<b>Notice of Allowability</b>	Application No.	Applicant(s)
	10/712,602	YORK, JACK MARTIN
	Examiner	Art Unit
	John Kreck	3673

### **EXAMINER'S AMENDMENT**

--Apparatus and Method for Removing Flooring Tile—

FIG. 1

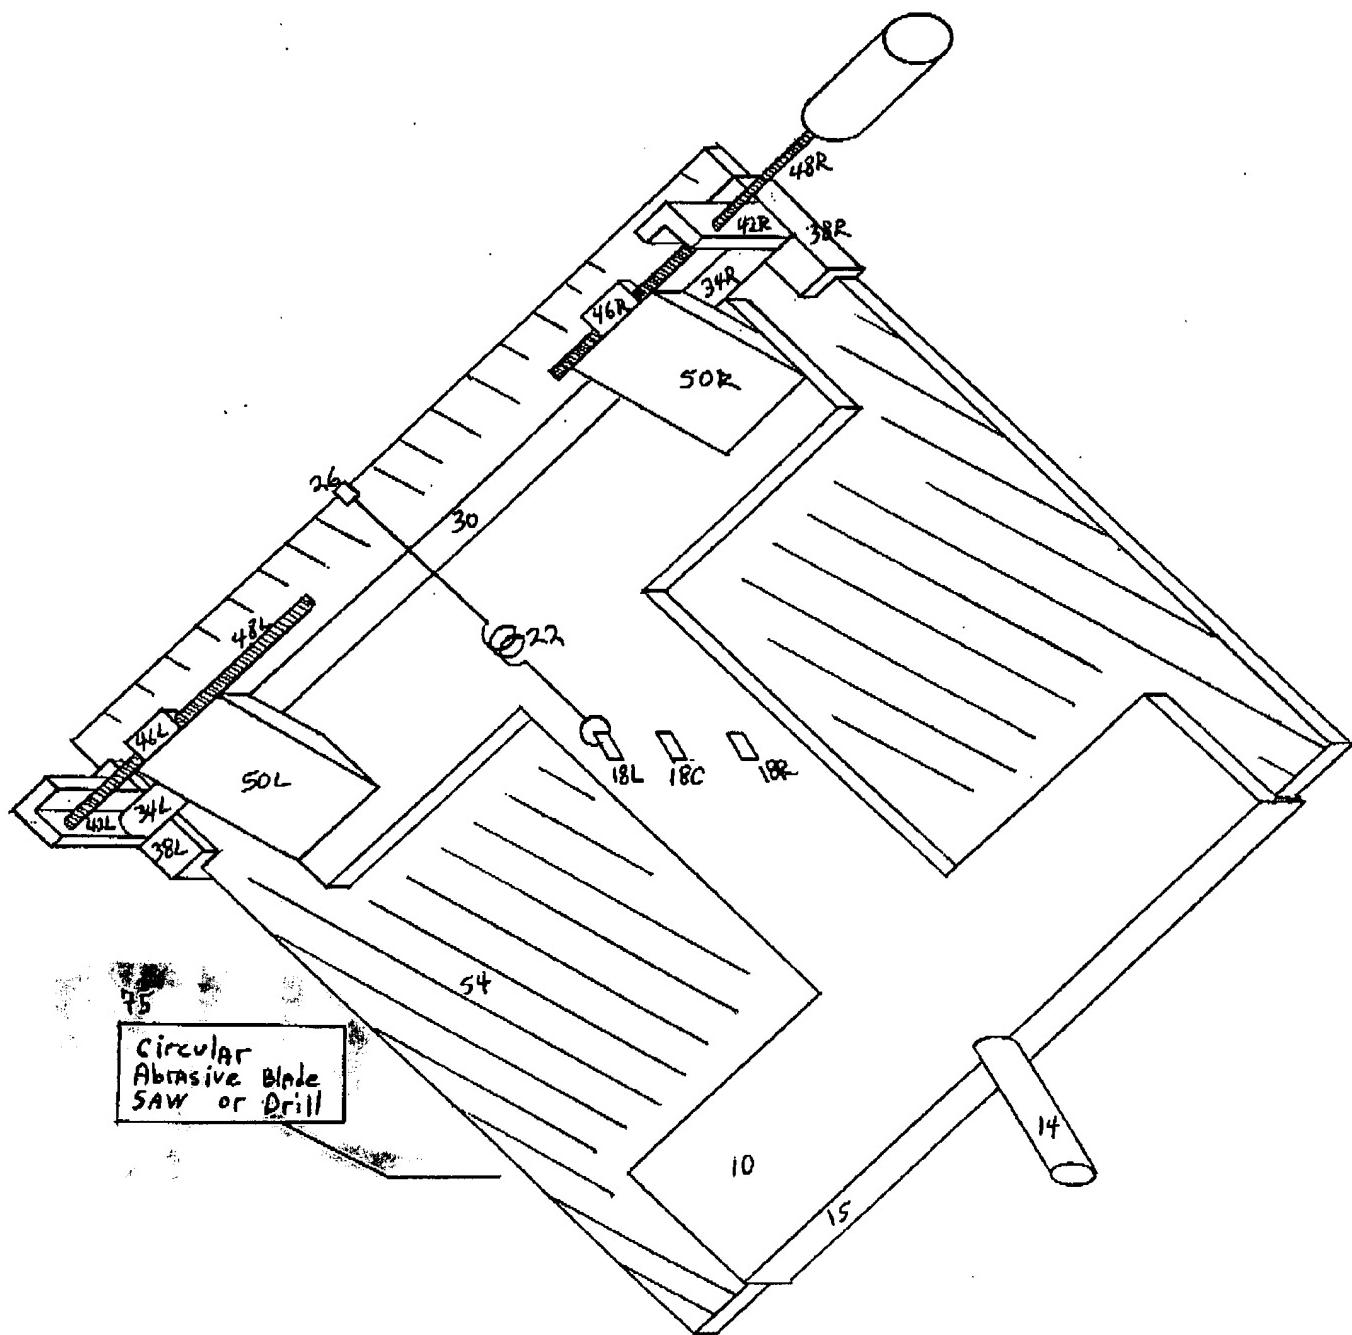
2. The following changes to the drawings have been approved by the examiner and agreed upon by applicant: in figure 1, a box has been added as shown on the following page. In order to avoid abandonment of the application, applicant must make these above agreed upon drawing changes.
